FIELD SERVICE BULLETIN

FSB Number: LVCCFSB2005-227
Author: Tony Bryan
Date: August 01, 2005
Total No. of Pages: 3
Subject: GSM V600/V600R – Lazy Flip
Phone Models: GSM V600, V600i, V620
Level of Repair: 2

Fig. 1.0 - Flip falls away from base, creating a gap between the flip and base bumpers

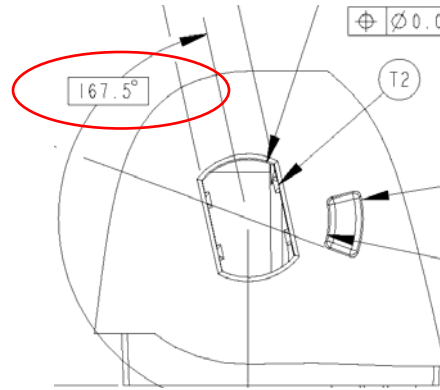
Service is aware of an issue, identified during field return analysis of the GSM V600/V600R product, where pressure applied to the flip at hyper-extend can result in the ‘Lazy Flip’ failure mode. See image below. The root cause is that the hinge cam, in the flip closed position, is not able to provide sufficient force to keep flip closed tight to the base. This allows the flip to open if phone is turned upside down. Severe cases, when used in an active use-case, may lead to customer returns for display flickering due to over cycling of the flip detect switch.

Adjust double D feature in right knuckle (P/N 1588188N01) to optimize hinge cam position.

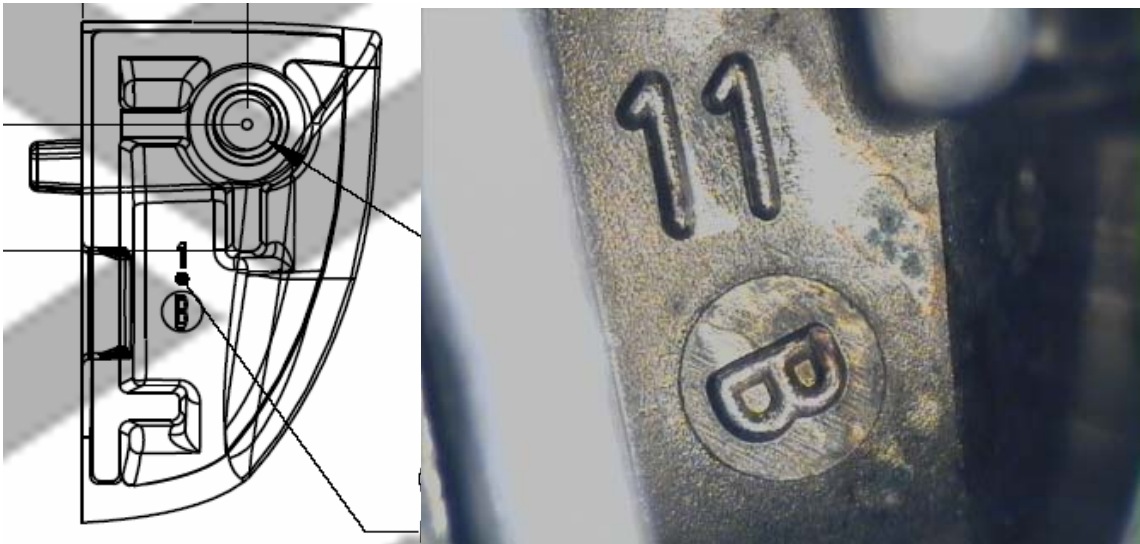
Change to 177.5°

With the new knuckle, there is no gap between bumper and flip housing.

The old knuckle P/N is 1588188**N01**, **Rev B**. You can see the Rev mark on the knuckle as follows.

The new knuckle P/N is 1588188**N02**, **Rev C**. You can see the Rev mark at same location as that of Rev. B.
